MICROWAVE ANTENNAS

KS-15676 HORN-REFLECTOR AND WAVEGUIDE SYSTEM

PERIODIC TEST INTERVALS

1.01 This Addendum to Section 402-421-330 Issue 2 is issued to add a note to paragraph 2.01 advising station forces to caution tower contractors against removing or adjusting the Axial Ratio Compensators on circular waveguides. This issue does not affect the Equipment Test List.

Fig. 1 — Axial Ratio Compensator

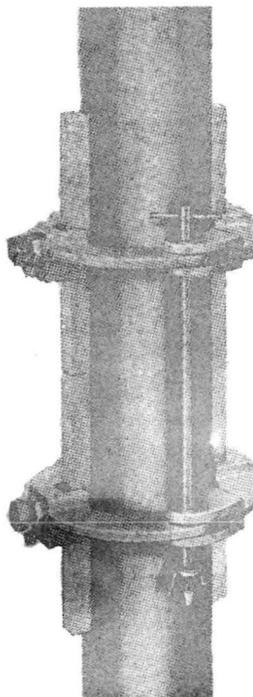
Caution: Adjustments must not be made on Axial Ratio Compensators (Fig. 1) by tower maintenance contractors. These compensators contain critical pressure adjustments for necessary cross-polarization of radio signals and should not be tightened or disturbed in any way.
